Our ref
PLAN-030018

Proposal: Enlarged replacement single storey extension with bathroom and dressing room in roof space.

Site: AL/77/19/HH: - 2 Tudor Cottage, Tudor Drive, Westergate, Aldingbourne, PO20 3YT.

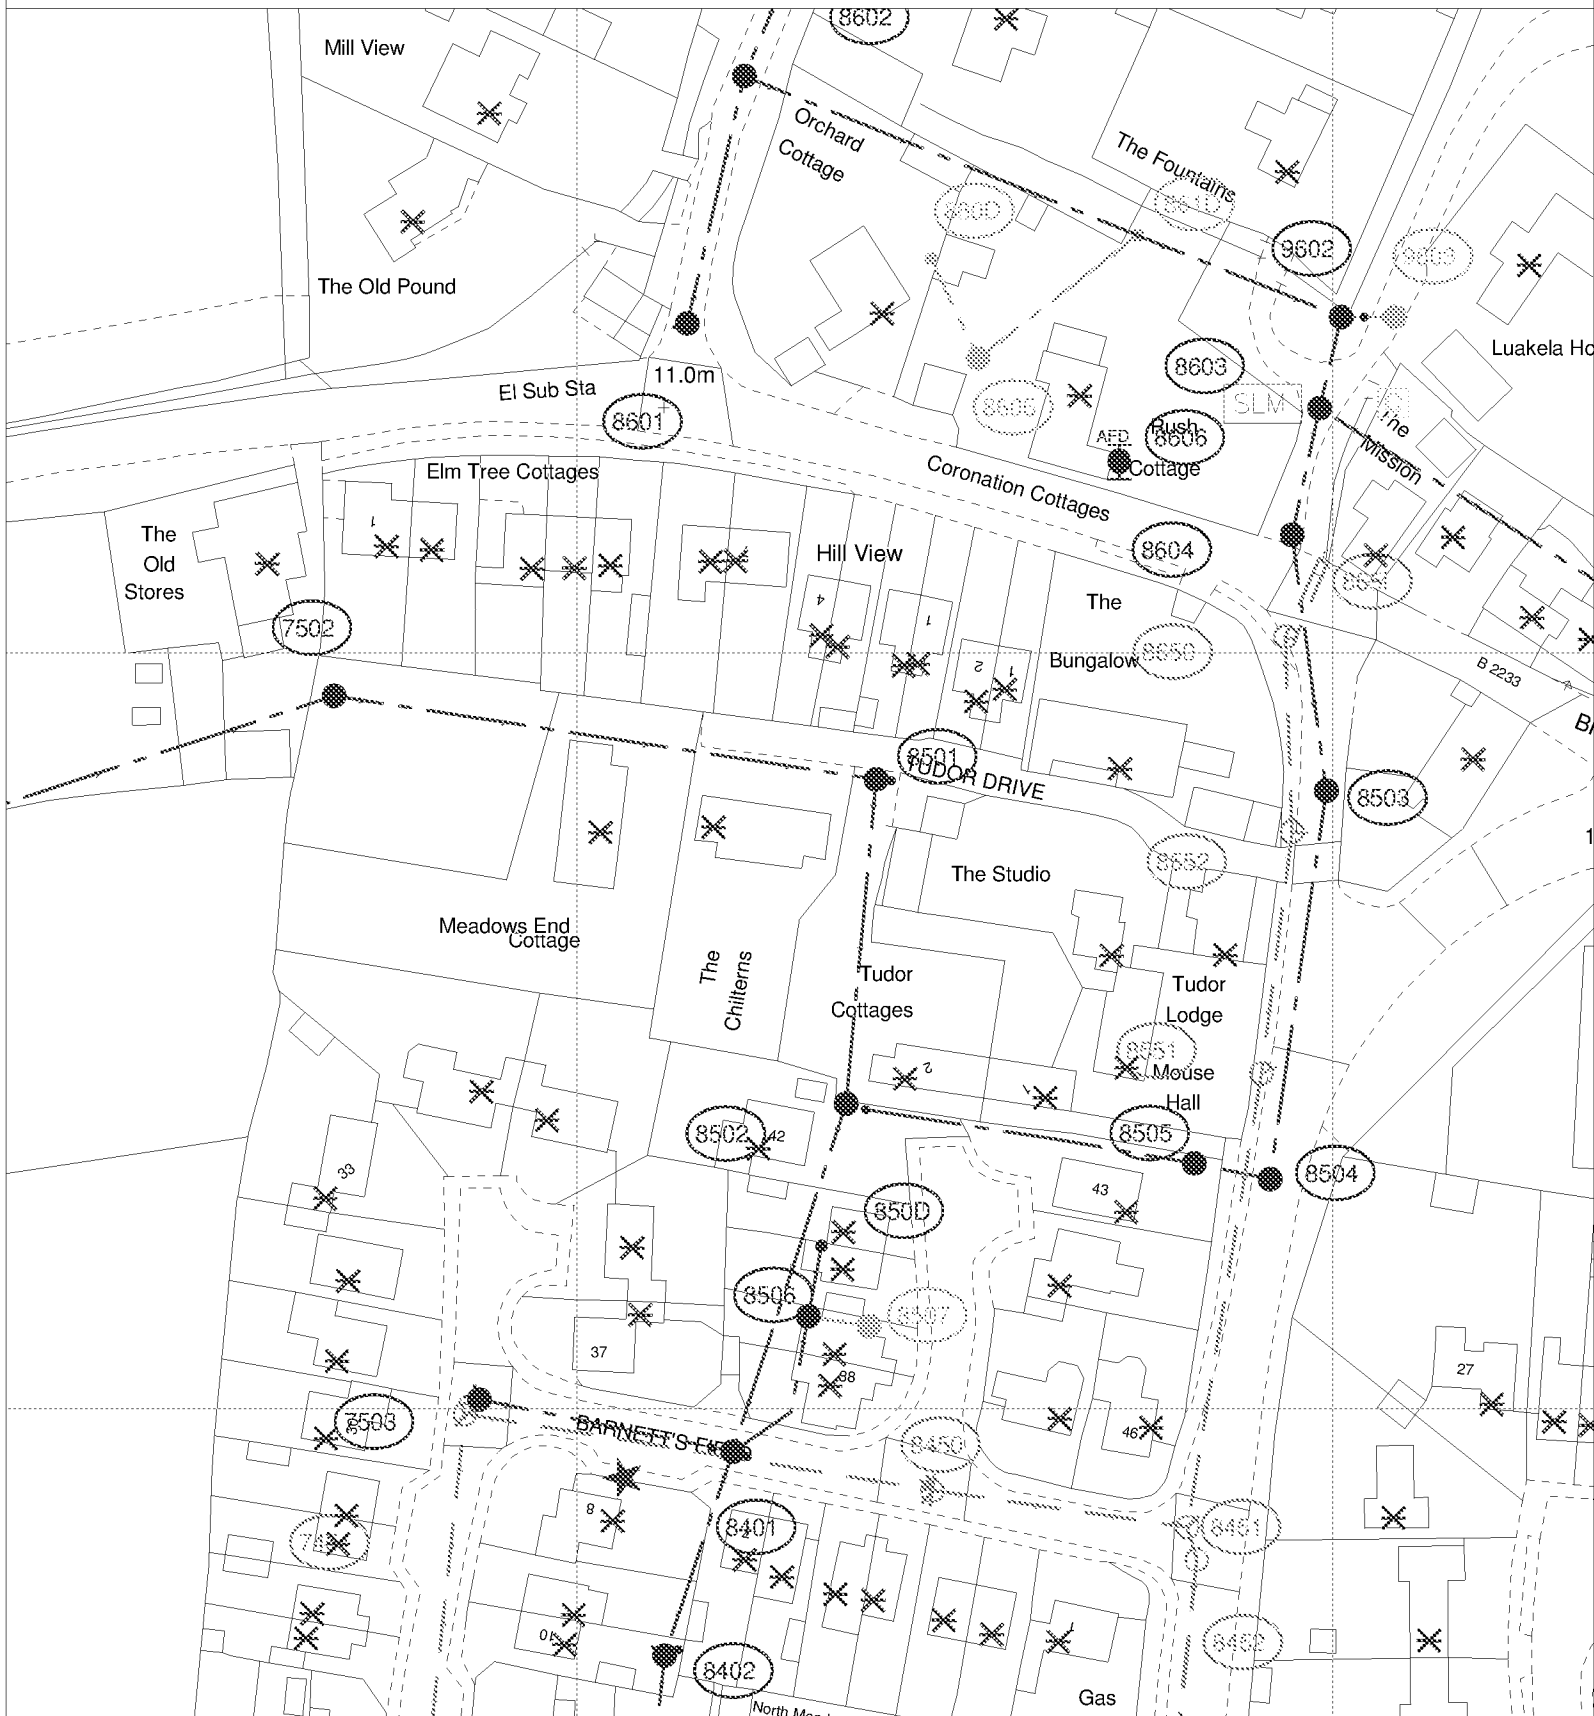
Please find attached a plan of the sewer records showing the approximate position of a public foul sewer crossing the site. The exact position of the public foul sewers must be determined on site by the applicant.

- The 150mm diameter gravity foul sewers requires a clearance of 3 metres on either side of the gravity sewers to protect it from construction works and to allow for future access for maintenance.
- No development or tree planting should be carried out within 3 metres of the external edge of the public gravity sewer without consent from Southern Water.
- No soakaways, swales, ponds, watercourses or any other surface water retaining or conveying features should be located within 5 metres of a public sewers.
- All existing infrastructure should be protected during the course of construction works.
